Delegated Report

Prior Approval Extensions Application

Application no:	20240613
Location	1 Marina Drive Northfleet Gravesend Kent
Proposal:	Prior approval application for a single storey rear extension with a depth of 4.00 metres, maximum height of 3.00 metres and eaves height of 2.85 metres.
Applicant:	Mrs Afsana Tanveer
Site Visit	N/A Desktop Assessment

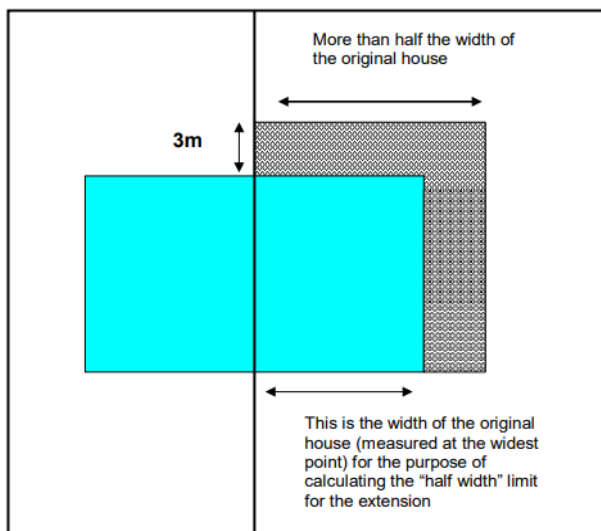
The proposed plans show the proposal would fail to comply with A.1 (j) (iii) as the total enlargement would extend beyond a wall forming a side elevation of the original dwellinghouse and have a width greater than half the width of the original dwelling. This is demonstrated visually below in the Government Technical guidance:

The information provided, shows the proposed development fails under Class A.1 (j) (iii), as the development would extend beyond a wall forming a side elevation of the original dwellinghouse and have a width greater than half the width of the original dwelling.

The proposed development does not comply with Class A.1 (j) (iii) of **THE TOWN AND COUNTRY PLANNING (GENERAL PERMITTED DEVELOPMENT) (ENGLAND) ORDER 2015, AS AMENDED**, and it is considered **PRIOR APPROVAL IS REQUIRED AND REFUSED**
